**Dimond Park Aquatic Center
Contract No. BE17-185**

ADDENDUM NO.: ONE

DATE ADDENDUM ISSUED: March 28, 2017

1 ENLARGED MECHANICAL PLAN - 2ND FLOOR FAN ROOM
 SCALE: 1/8" = 1'-0"
 GRAPHIC SCALE IN FEET

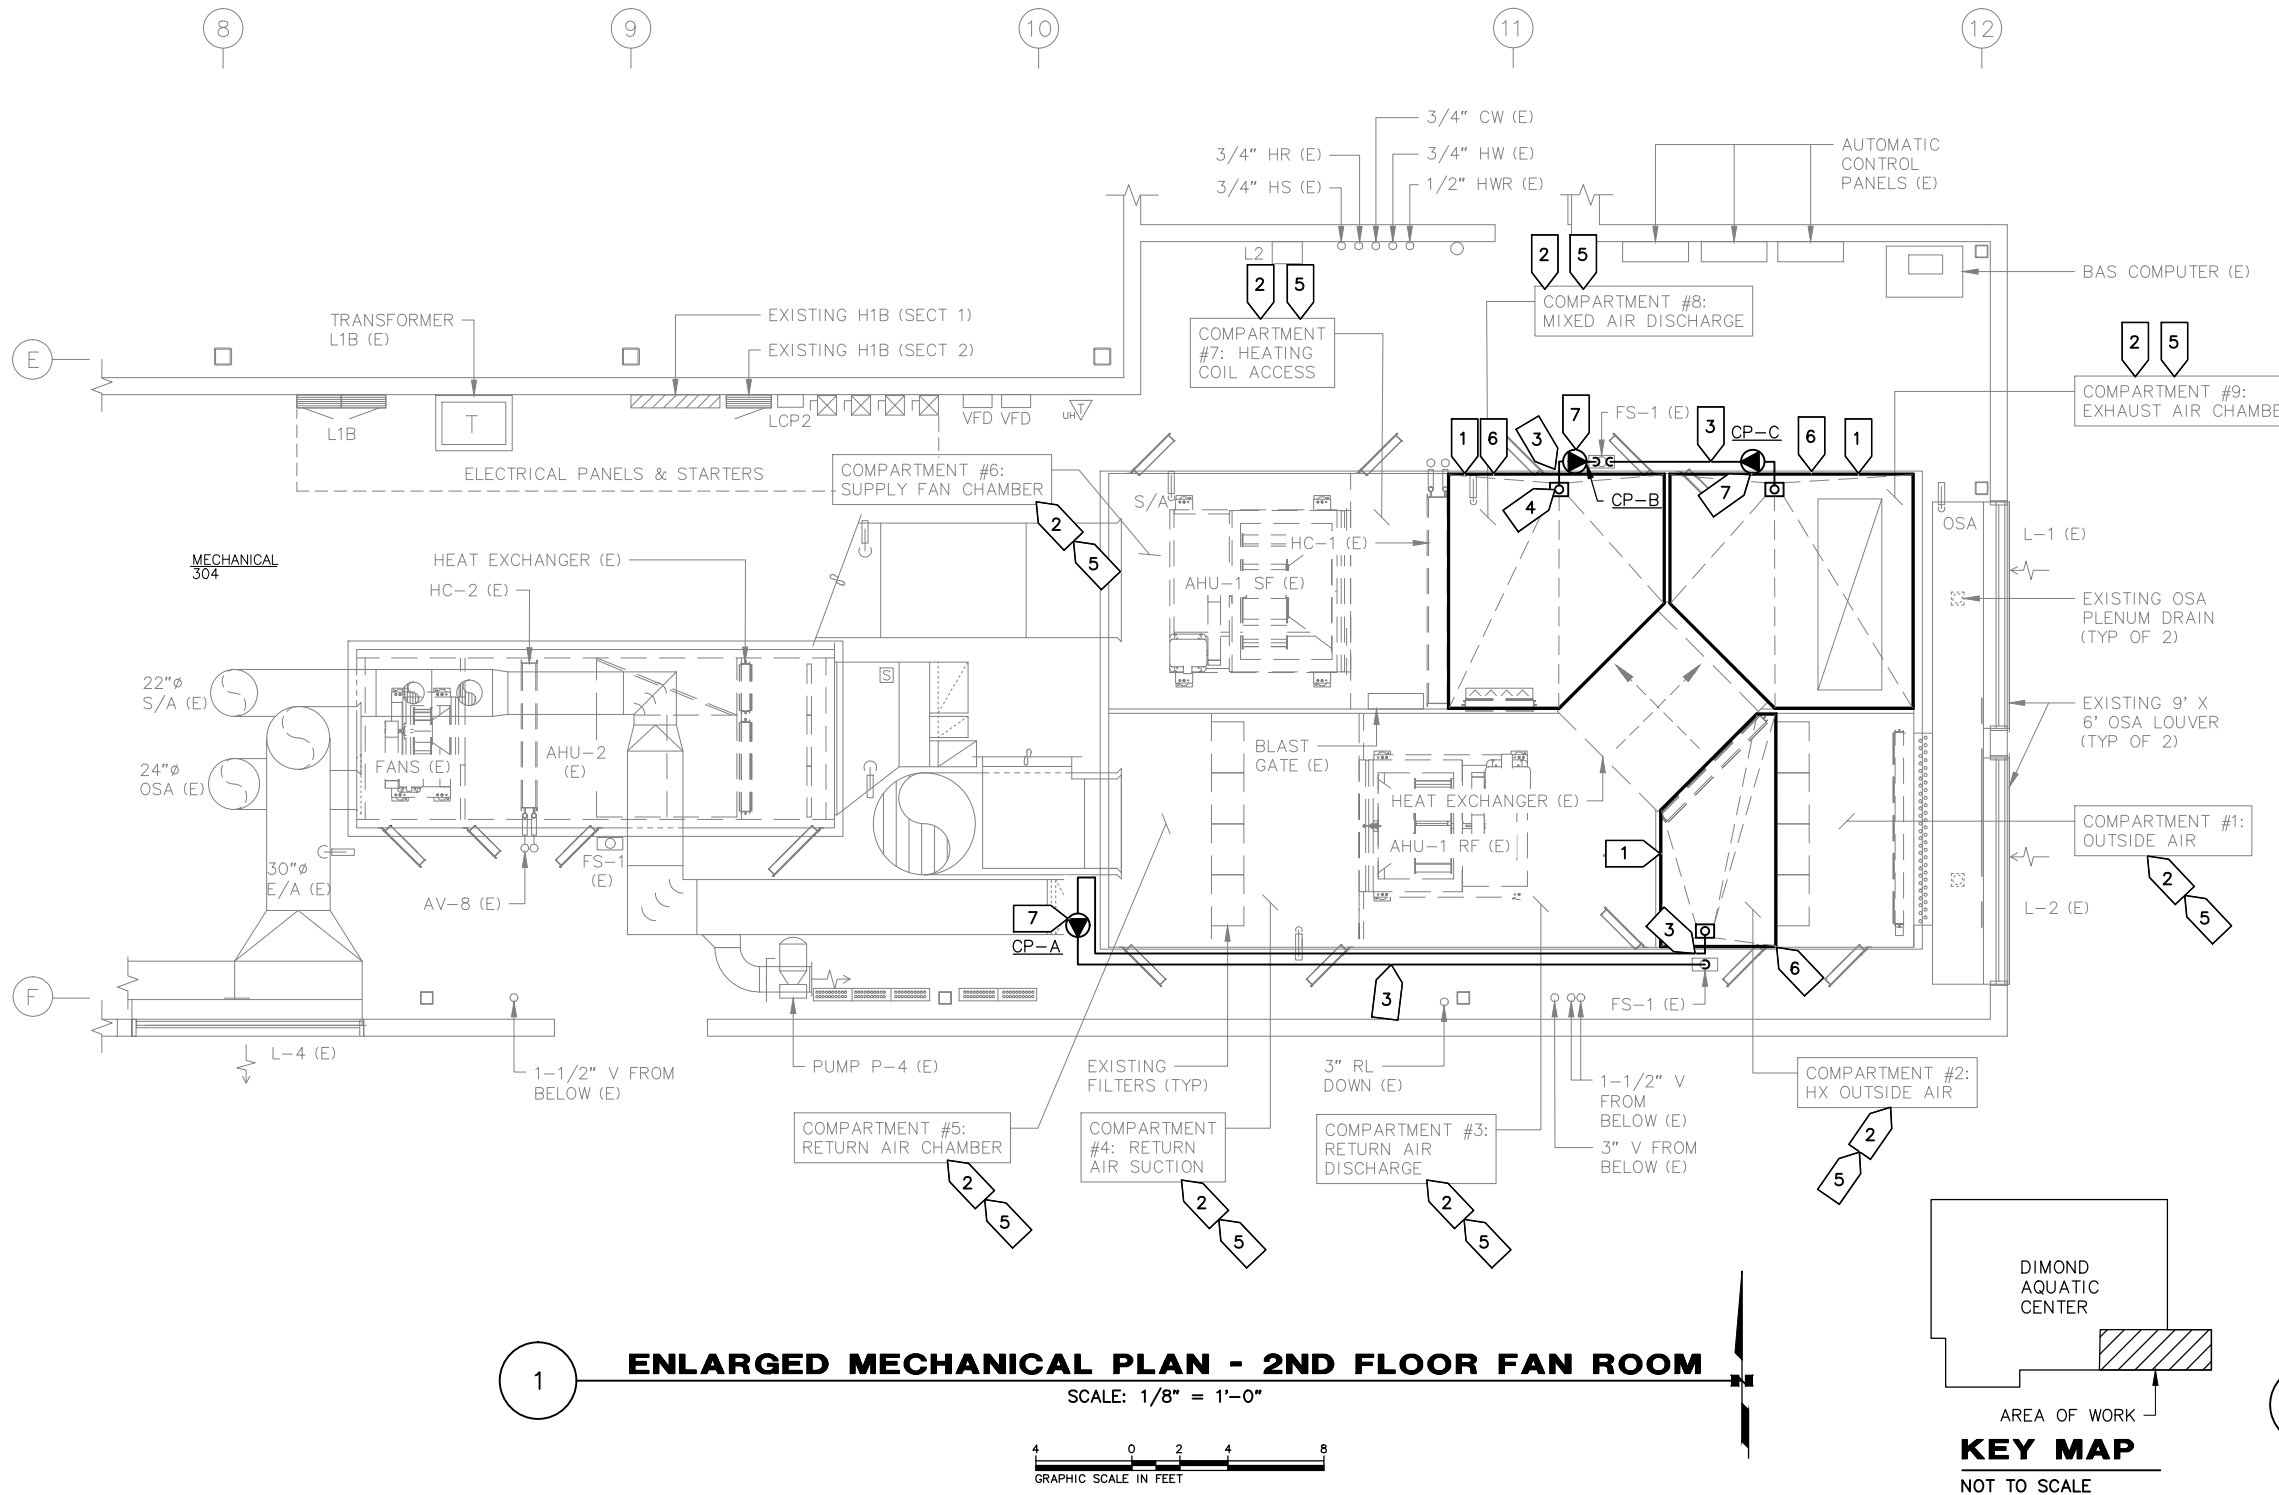
- Item No. 1 M002 MECHANICAL SPECIFICATIONS, ***Delete and replace with the attached*** M002 MECHANICAL SPECIFICATIONS, labeled Addendum No. 1, dated 2/2017. Specifications have been revised for epoxy coatings.
- Item No. 2 M500 MECHANICAL ENLARGED PLAN – AHU-1(E) ***Delete and replace with the attached*** M500 MECHANICAL ENLARGED PLAN – AHU-1(E) labeled Addendum No. 1, dated 2/2017. Sheet Note 6 has been revised.
- Item No. 3 M602 MECHANICAL DETAILS AND PHOTOS – AHU-1(E) ***Delete and replace with the attached*** M602 MECHANICAL DETAILS AND PHOTOS – AHU-1(E), labeled Addendum No. 1, dated 2/2017. Detail 1- Drain Pan Detail has been revised.

- FOR DRAIN PAN DETAIL SEE 1/M602.
 - FOR DRAIN PIPING DETAIL SEE 2/M602.
- ADDENDUM 1**
- APPLY NEW EPOXY COATING, TO WALLS OF AHU-1(E) IN COMPARTMENTS #2, #8, AND #9.

- APPLY NEW EPOXY COATING, TO WALLS OF AHU-1(E) IN COMPARTMENTS #2, #8, AND #9.
 - INSTALL NEW PUMPS, CP-A, CP-B, AND CP-C, AT THIS LOCATION. PUMPS ARE TO BE INSTALLED IN ACCORDANCE WITH MANUFACTURER'S INSTRUCTIONS.
